(Comanche Peak Steam Electric
Station, Units 1 and 2)

CASE'S MOTION FOR RECONSIDERATION OF
LICENSING BOARD'S 6/29/84 MEMORANDUM AND ORDER
(Written-Filing Decisions, #1: Some AWS/ASME Issues)

Observation Record

PIPE SUPPORT CC-1-028-725-S33R

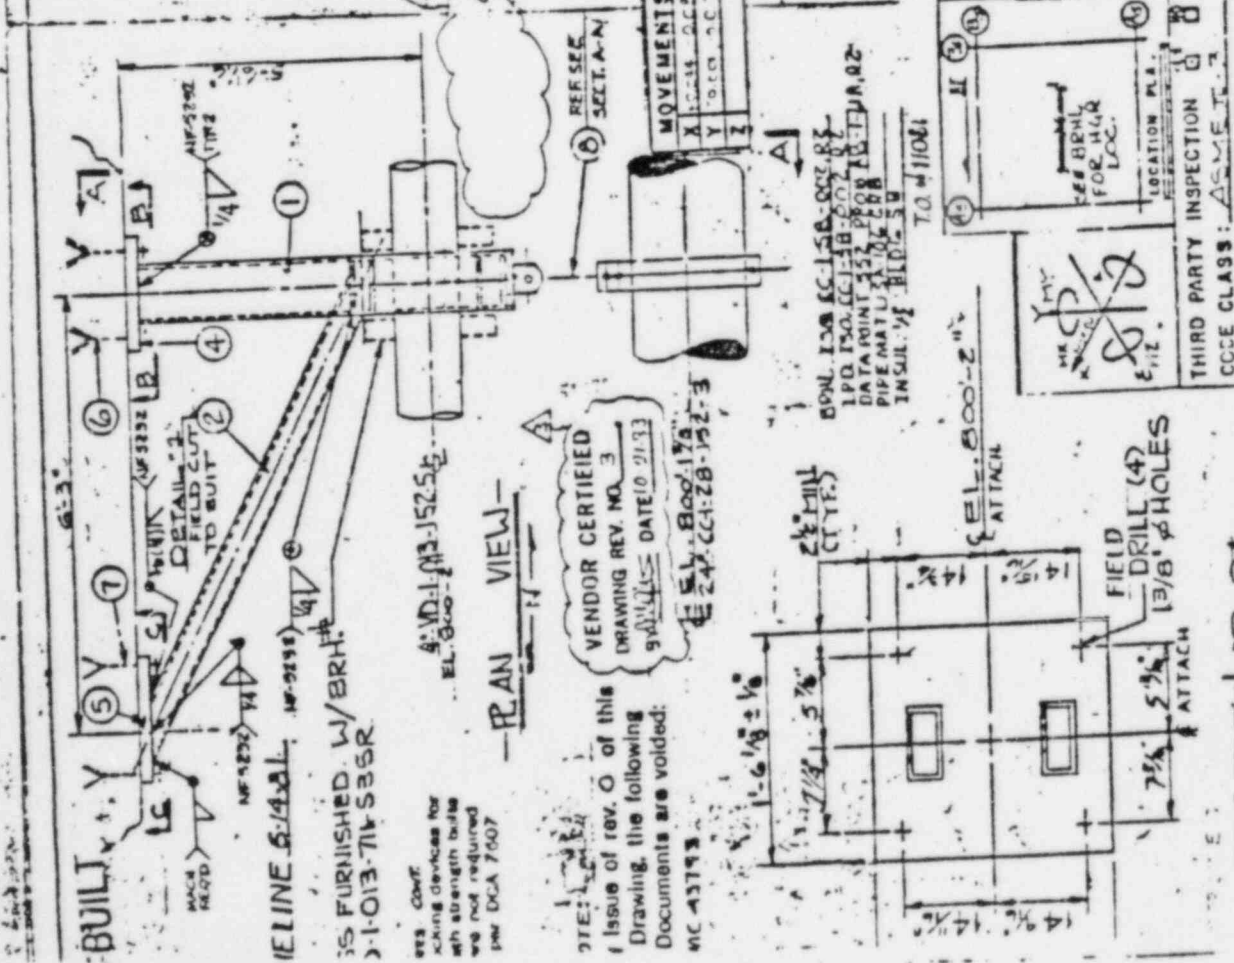
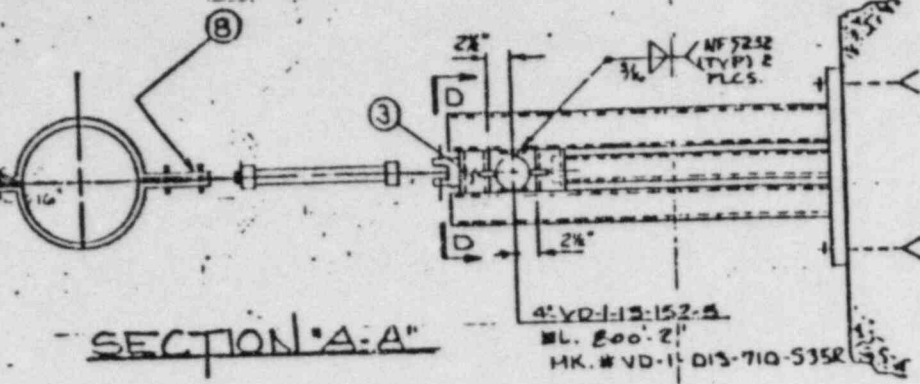
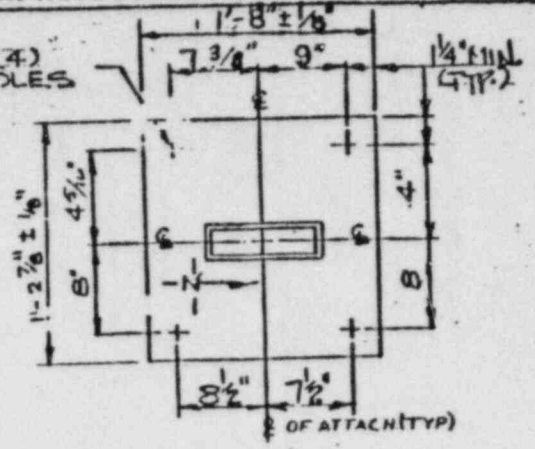
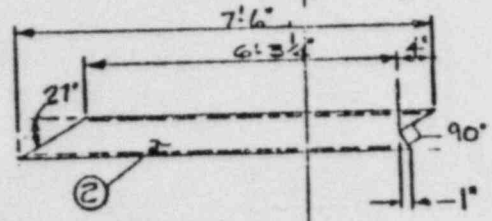
The fillet weld size specified on the following drawings is smaller than the minimum fillet weld size required by the ASME B&PV Code:

- Support CC-1-028-725-S33R, fillet weld between items 1 and 4.
- Support CC-1-031-009-S33R, fillet weld at support nodes 6 and 11.

22. Is the design of the welded connection of the members in accordance with Cygna Criteria 84042-DC-2, Section 4.1.10?		X		Weld of Item 1 to Item 4 is shown and checked as a 1/4" fillet. 5/16" fillets are minimum required. Weld is acceptable per TIGCO response dated June 8, 84 to Cygna Question 31 (see Observation PS-04). The weld of Item 3 to Item 1 is checked using enveloped emergency loads. The actual and allowable loads were incorrect, and wrong weld pattern was used in calculations. However, the welds are acceptable per Cygna calculation F-13 (84042, 4-F).

In their response, dated June 8, 1984, question 31, TUGCO concurs with Cygna's observations that the welds are 1/16" undersize on the drawing. In that letter, TUGCO has noted that both drawings were revised and reissued for vendor certification.

In the 131 supports (with numerous welds) reviewed by Cygna in Phase 3, these were the only two weld size violations. As such, Cygna considers the error isolated. In addition, neither weld violation had design impact since the loads on both welds were small. Therefore, this observation is closed.
